Operational change

Release point 4 moved east

- *Valid from: 04.07.2025*
- *Valid to: UFN*
- *Version number: 02-2025*

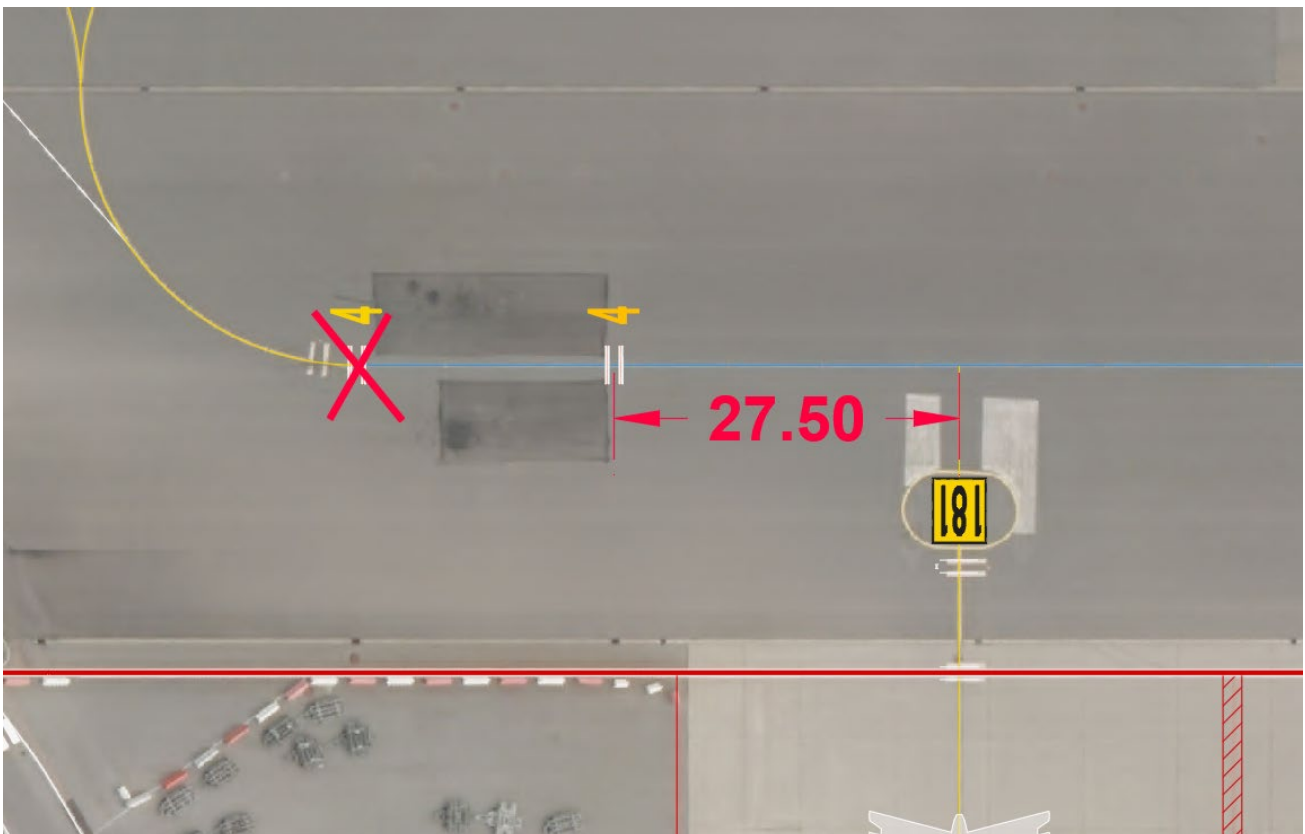
Due to damage in the asphalt on existing release point 4, the release point will be moved 20 meters to the east. This change will result in less rotation in the aircraft wheel. This will in turn cause less tear on the asphalt.

Release point 4 is moved approximately 20 M east on taxiway Lima blue. Distance to stand 181 from new release point location is 27.50 meters.

Push back will be conducted to the new location of release point 4.
